SERVICE BULLETIN

EL15-004a

April 28, 2015

NV200 AND NV200 TAXI; CRANK NO START BELOW FREEZING AFTER OVERNIGHT COLD SOAK AND DTC U1000 STORED

Figure 1

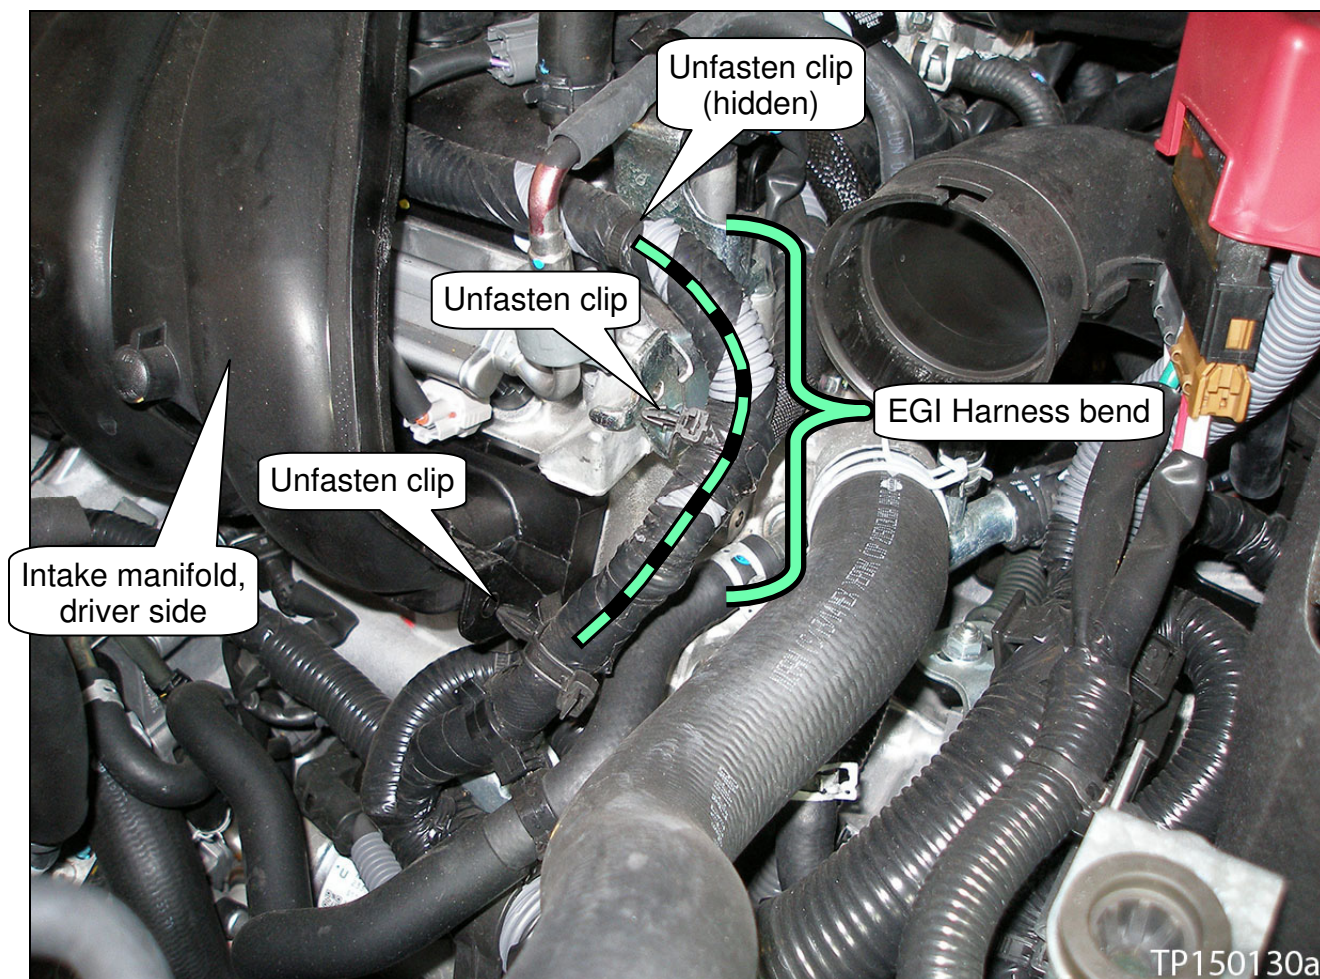
2. Disconnect both battery cables, negative cable first.
 - Make sure to use suitable protection on the fenders and bumper facia as needed.
3. Remove the front air duct.
4. Locate the bend in the EGI harness where shown in Figure 1.
5. Unfasten the three (3) clips where shown in Figure 1.

Figure 3

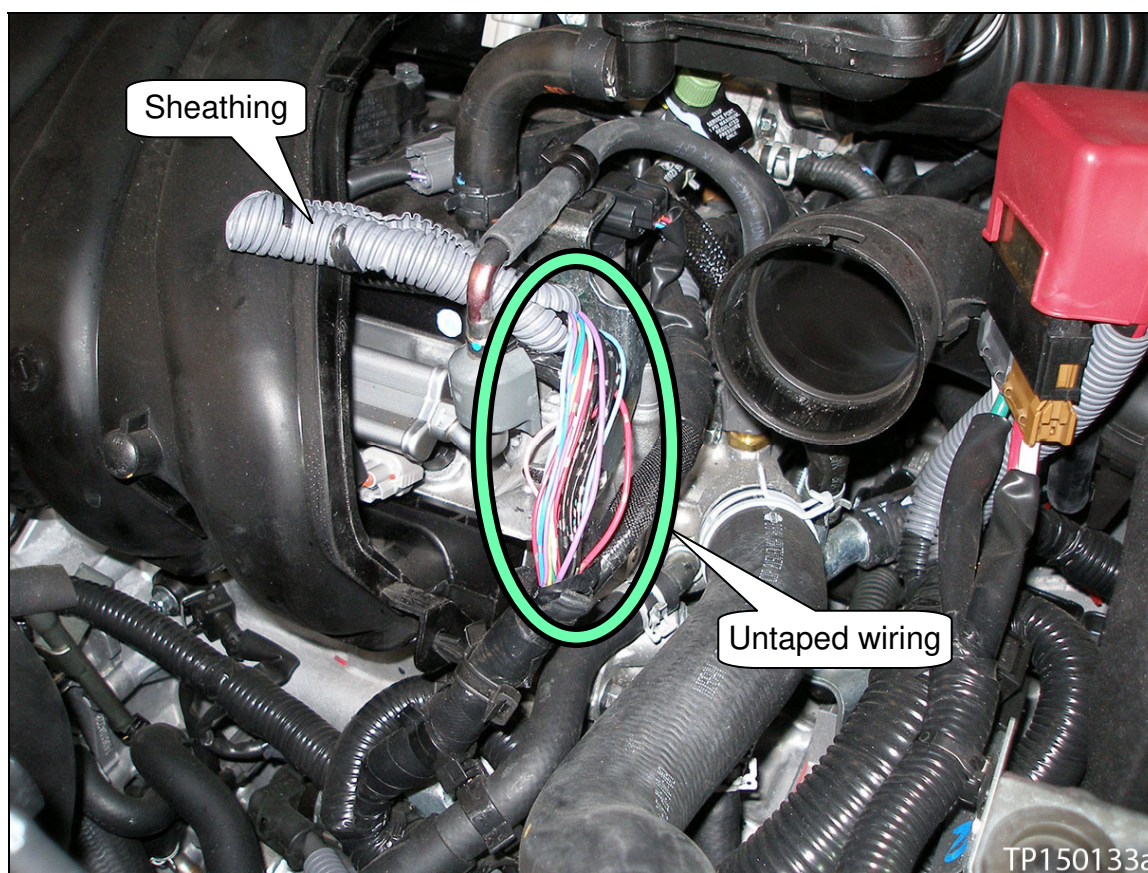
7. Untape the sheathing, and then pull back the sheathing out of the way (see Figure 3).
8. After pulling back the sheathing, untape the wiring (see Figure 3).

Figure 4

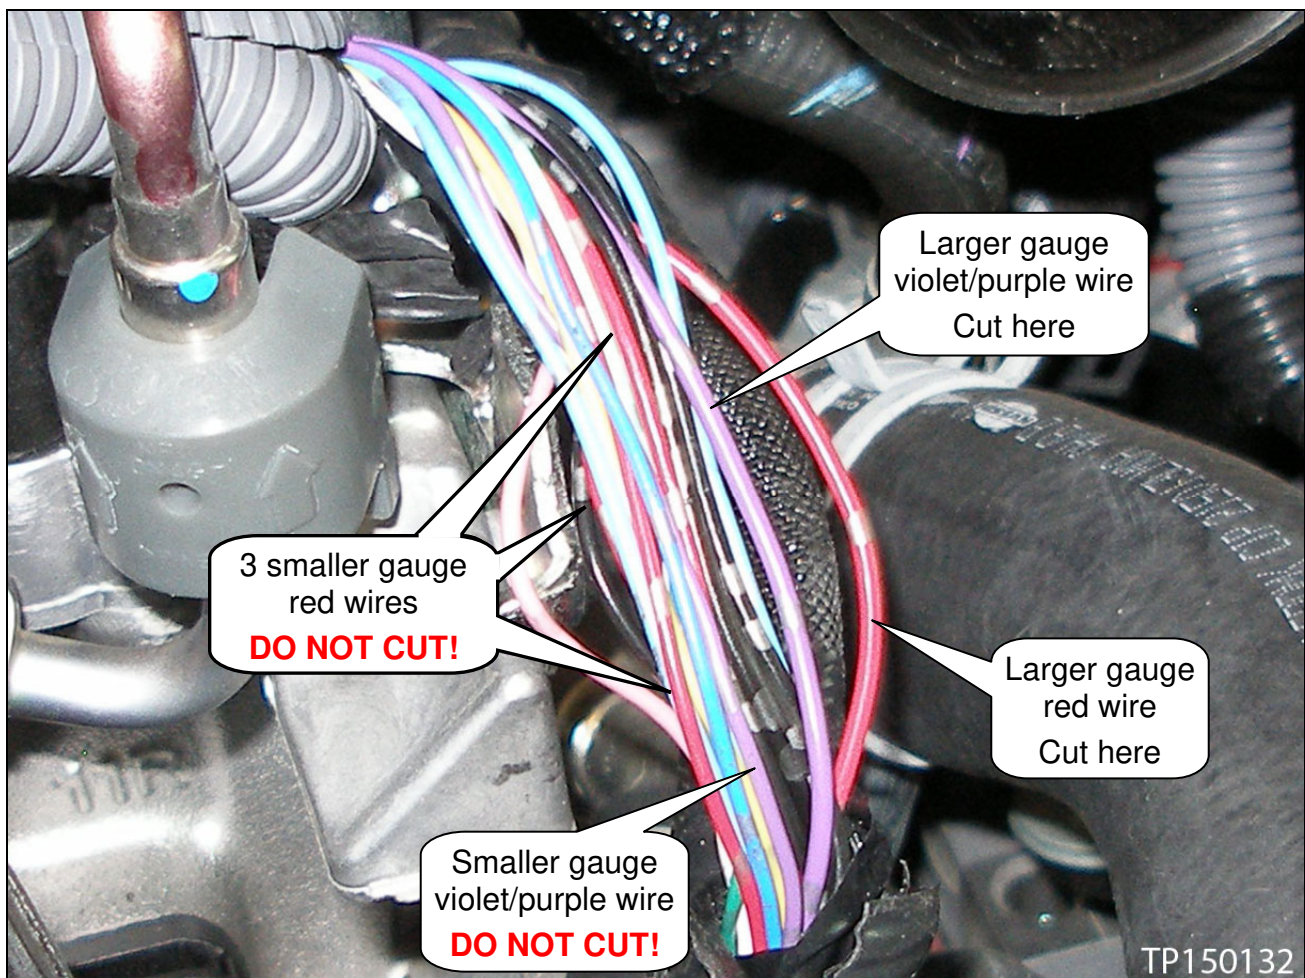
9. Locate and cut the thicker 16 Gauge/1.25 mm red wire (see Figure 4).

- Cut this wire further down the harness (see Figure 4). Leave enough length to install a piece of heat shrink tubing.

CAUTION: There are four (4) red wires in this section of the EGI harness. One is a thicker gauge (16 Gauge/1.25 mm) than the remaining three (3) wires. Make sure to cut the 16 gauge red wire.

10. Locate and cut the thicker 16 Gauge/1.25 mm violet/purple wire (see Figure 4).

- Cut this wire about in the middle of the exposed wiring (see Figure 4).

CAUTION: There are two (2) violet/purple wires in this section of the EGI harness. One is a thicker gauge (16 Gauge/1.25 mm) than the other violet/purple wire. Make sure to cut the 16 gauge violet/purple wire.

Figure 5

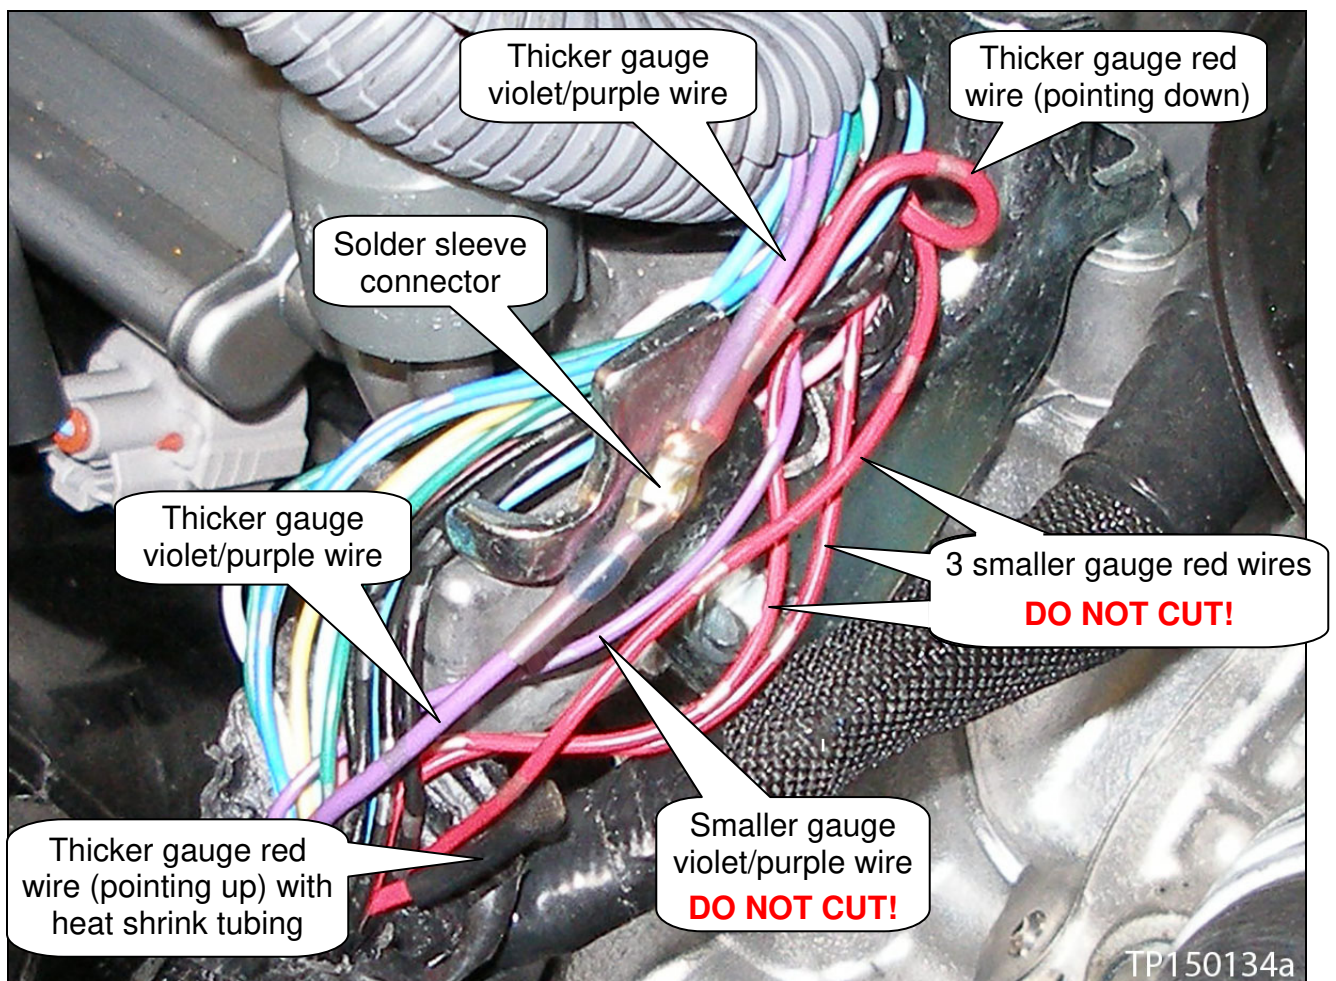
11. Connect/splice together the end of the red wire pointing down with both ends of the violet/purple wire with a “blue” solder sleeve connector (see **PARTS INFORMATION**).

- See Figure 5.
- Refer to NTB03-078 for solder sleeve connector installation procedure.

12. Place a one inch piece of heat shrink tubing on the red wire pointing up (see Figure 5).

- Leave about ½ inch of tubing past the end of the red wire.

13. Install the heat shrink tubing by applying heat with Flameless Heat Gun J-46538 or equivalent (see Figure 5).
